**GILMORE ELEMENTARY SCHOOL WASTEWATER TREATMENT PLANT
REPLACEMENT**

ADDENDUM #1

FEBRUARY 23, 2022

THRASHER PROJECT #020-10105

E4

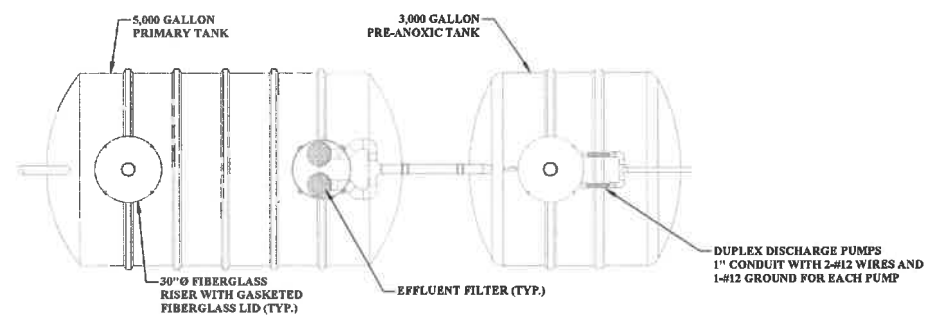
3. On the Underground Entrance, the drawings show 2" conduit. AEP will likely require 3" conduit. Pull length will be over 400' with a minimum of 3 long sweep 90's. They may require a pull box.

AEP will field-verify the conduit size and need for a pull box. Assume 3" conduit with no pull box will be required for bidding purposes. Plan sheet E4 has been updated to reflect this.
